AUSTRALIAN TURF CLUB NIGHT RACING – RESPONSE TO SUBMISSIONS – HISTORICAL AND ABORIGINAL ARCHAEOLOGY

AUSTRALIAN TURF CLUB - ROYAL RANDWICK RACECOURSE NIGHT RACING - ADDENDUM HISTORICAL ARCHAEOLOGICAL IMPACT ASSESSMENT.

AUSTRALIAN TURF CLUB NIGHT RACING - ADDENDUM ABORIGINAL DUE DILIGENCE ASSESSMENT

Figure 1 – Overlay of proposed works on areas of identified archaeological significance from GML 2006 CMP.

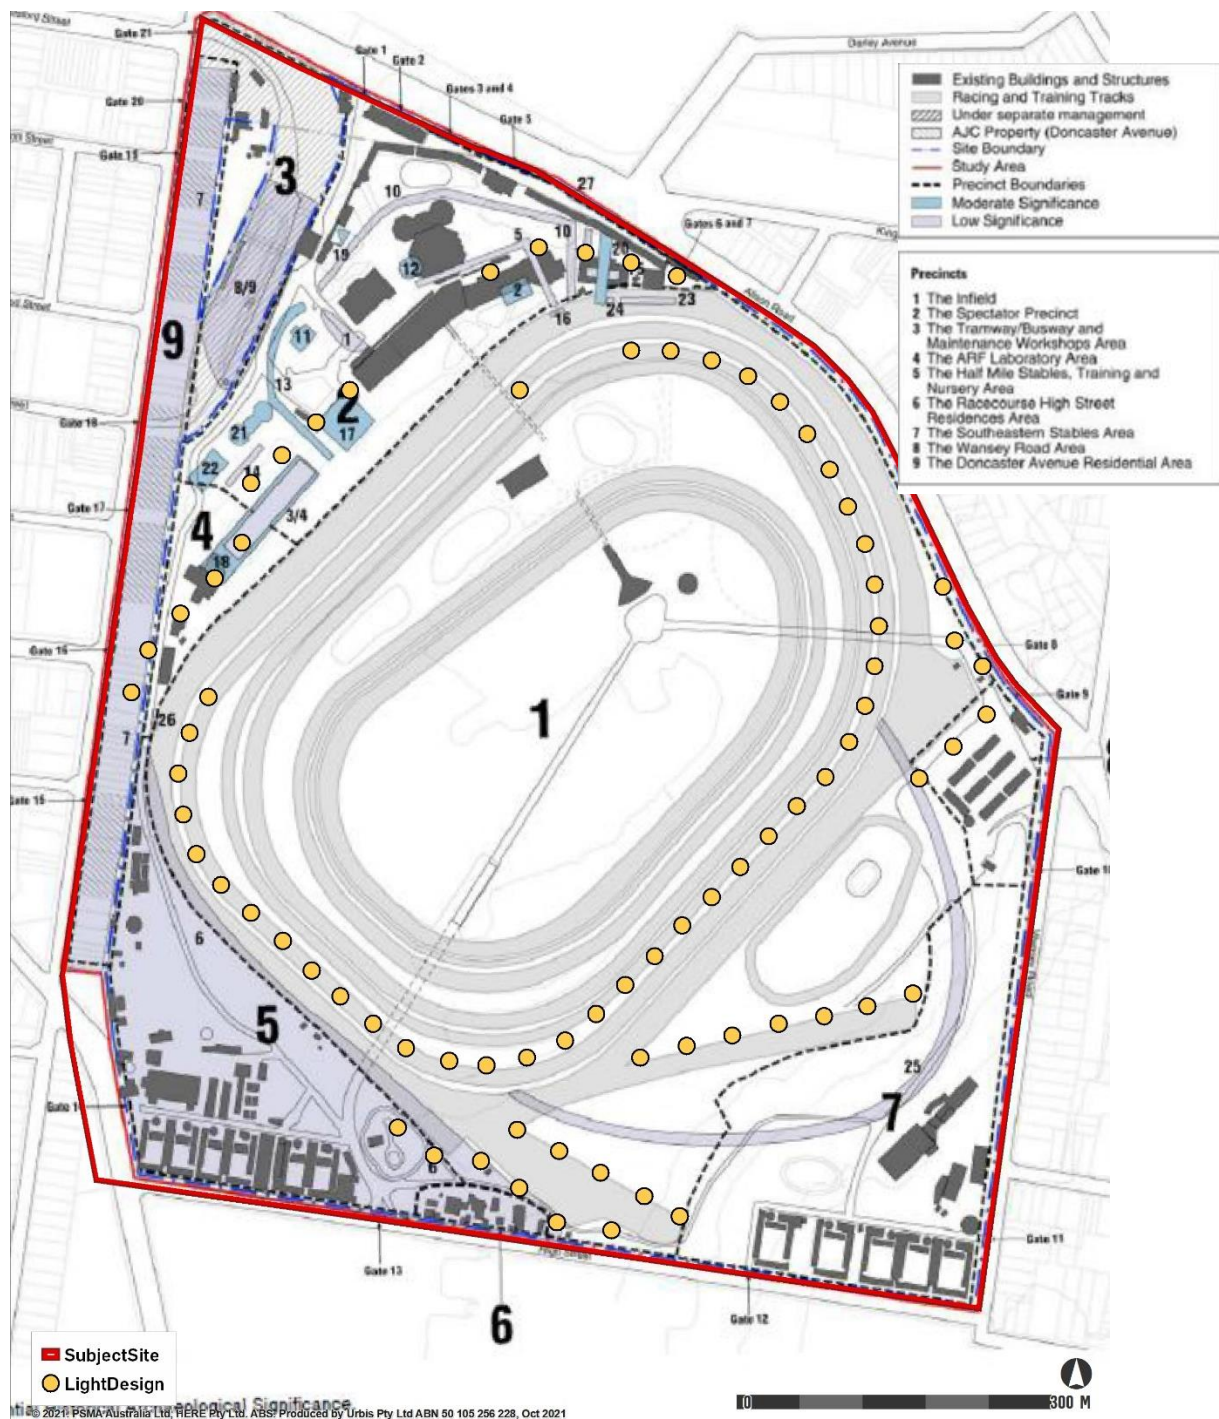
38. The Heritage Impact Statement prepared by Urbis includes the Potential Historical Archaeological Significance mapping from the 2006 Godden Mackay Logan Conservation and Management Plan for the site which identifies areas on the site having Moderate-Significance and Low Significance in relation to historical archaeological sensitivity.

No assessment of the proposal in relation to this mapping has been provided however, and the SSD submission is deficient in this regard.

39. The Potential Historical Archaeological Significance mapping identifies a number of sites within the Spectator Precinct and the ARF Laboratory Area, associated with previous structures, as being of Moderate significance and it is unclear whether excavation for the footings of the proposed light columns will impact on these archaeological values.

Figure 1 below represents areas of potential archaeological significance as identified by GML in the CMP, with an overlay of the proposed works. The Royal Randwick Race Course has been divided into 9 precincts as a means of portraying the different functional and physical attributes of each area (GML 2006b:i). The majority of the light designs are located in areas with nil (low) archaeological significance, such as in precincts 1, 2, 4, 5, 8 and 9.

Figure 1 shows two light designs located within the Doncaster Avenue Residential Area (precinct 9). The archaeological deposits likely to be found within precinct 9 consists of the structural elements associated with stables/out buildings/sheds, i.e. concrete slab footings (GML 2006b:xxii).

Within precincts 2 and 4, there are three light designs located within areas of local (medium) archaeological significance, primarily the areas within the vicinity of the Queens lawn and Leger lawn. These two areas previously contained two structures built in the early twentieth century that are now demolished, namely the Ladies (Members'/Queen's) Stand and the Third St Leger Stand. The likely archaeological potential in these areas may consist of the remnants of structural footings, amenities, as well as some brick structural elements (GML 2006b:xvi & xxii). In accordance with the CMP, areas of moderate archaeological potential are considered to contain partially disturbed archaeological deposits. These deposits are associated with important phases of the sites history that are subsequently able to potentially provide new information (GML 2006a:137).

As identified by the below diagram, the proposed light poles are located primarily within the track area, which is identified as of low (nil) significance by GML, resulting from high levels of disturbance with potential archaeological relics unlikely to occur, and should they occur unlikely to contain a high degree of spatial and physical integrity. As such, should any archaeological resources occur within this area, they are unlikely to satisfy the criteria for significance as the high levels of disturbance would reduce the research potential.
